LAZY Y AND ROCKING J SUBDIVISION

LOCATED IN THE SOUTH HALF OF SECTION 7
TOWNSHIP 12 SOUTH, RANGE 63 WEST OF THE 6TH P.M.
GRADING AND EROSION CONTROL PLANS
COUNTY OF EL PASO, STATE OF COLORADO

GEC

SHEET 3 OF 6
JOB NO. 25228.00

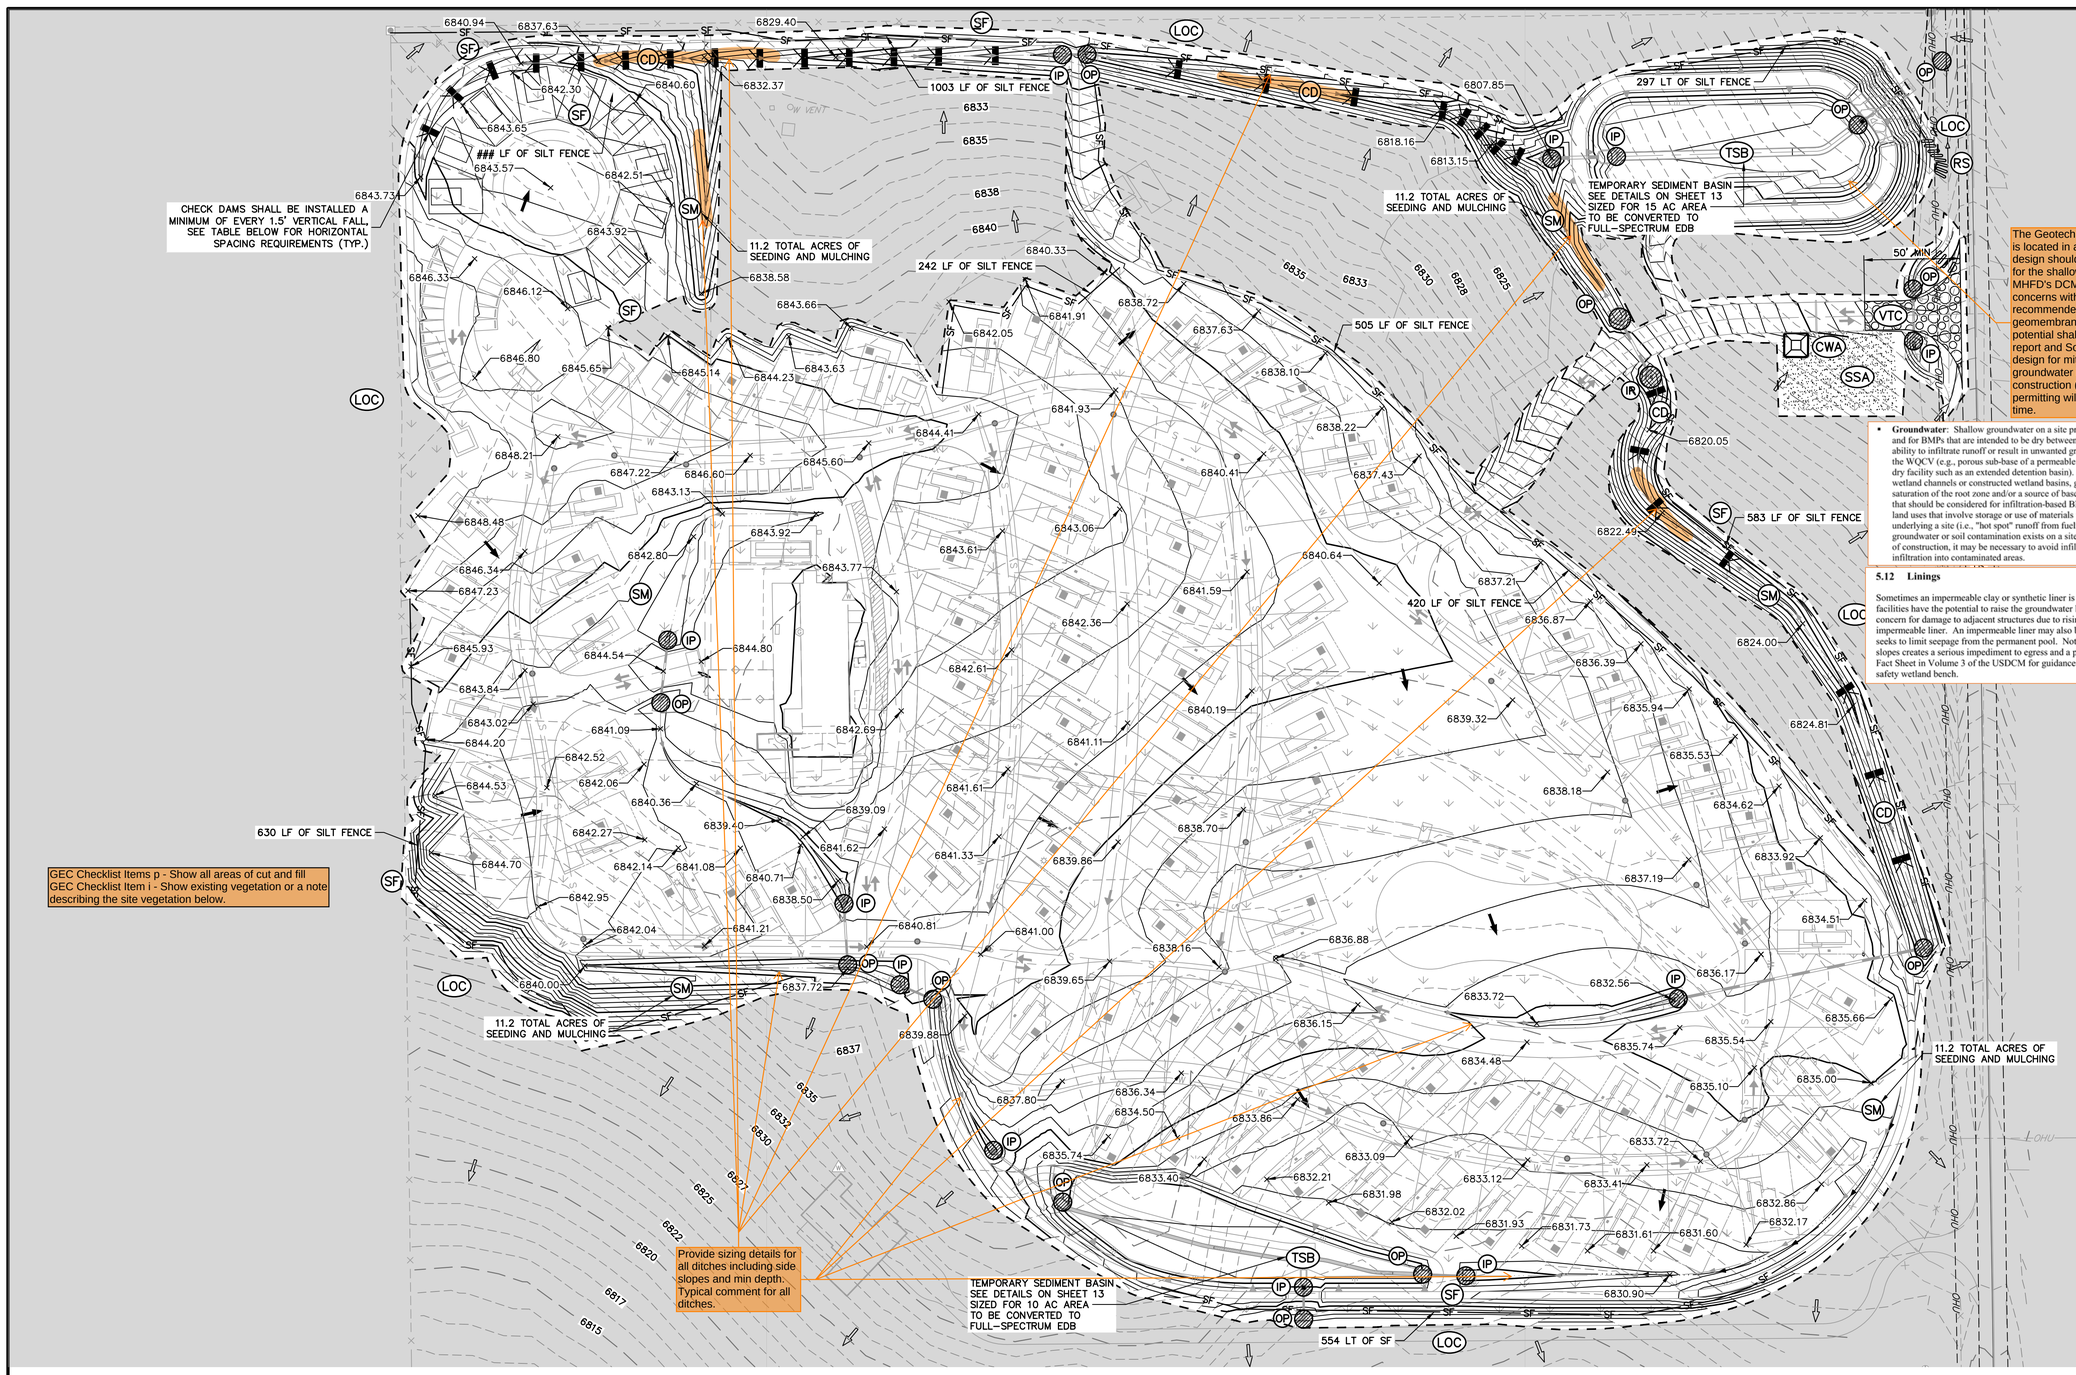
The Geotechnical report indicates that the pond is located in an area of shallow groundwater. The design should incorporate mitigation measures for the shallow groundwater. See excerpts from MHFD's DCM Volume 2 and 3 for potential concerns with groundwater in an EDB and the recommended mitigation options (like a clay or geomembrane liner). Please discuss this potential shallow groundwater in the drainage report and Soils Report text. If you decide not to design for mitigation now and shallow groundwater is encountered during or after construction (or at PA/FA), proper mitigation and permitting will need to be implemented at that time.

- **Groundwater**: Shallow groundwater on a site presents challenges for BMPs that rely on infiltration and for BMPs that are intended to be dry between storm events. Shallow groundwater may limit the ability to infiltrate runoff or result in unwanted groundwater storage in areas intended for storage of the WQCV (e.g., porous sub-base of a permeable pavement system or in the bottom of an otherwise dry facility such as an extended detention basin). Conversely, for some types of BMPs such as wetland channels or constructed wetland basins, groundwater can be beneficial by providing saturation of the root zone and/or a source of baseflow. Groundwater quality protection is an issue that should be considered for infiltration-based BMPs. Infiltration BMPs may not be appropriate for land uses that involve storage or use of materials that have the potential to contaminate groundwater underlying a site (i.e., "hot spot" runoff from fueling stations, materials storage areas, etc.). If groundwater or soil contamination exists on a site and it will not be remediated or removed as a part of construction, it may be necessary to avoid infiltration-based BMPs or use a durable liner to prevent infiltration into contaminated areas.

Sometimes an impermeable clay or synthetic liner is necessary. Stormwater detention and retention facilities have the potential to raise the groundwater level in the vicinity of the basin. Where there is concern for damage to adjacent structures due to rising ground water, consider lining the basin with an impermeable liner. An impermeable liner may also be warranted for a retention pond where the designer seeks to limit seepage from the permanent pool. Note that if left uncovered, synthetic lining on side slopes creates a serious impediment to egress and a potential drowning hazard. See the Retention Pond Fact Sheet in Volume 3 of the USDCM for guidance and benefits associated with the constructing a safety wetland bench.

GEC Checklist Items H and M. If "limits of disturbance" and "construction boundary" are the same, change to "limits of construction/disturbance" or otherwise show as separate line types for each on the legend and figure.
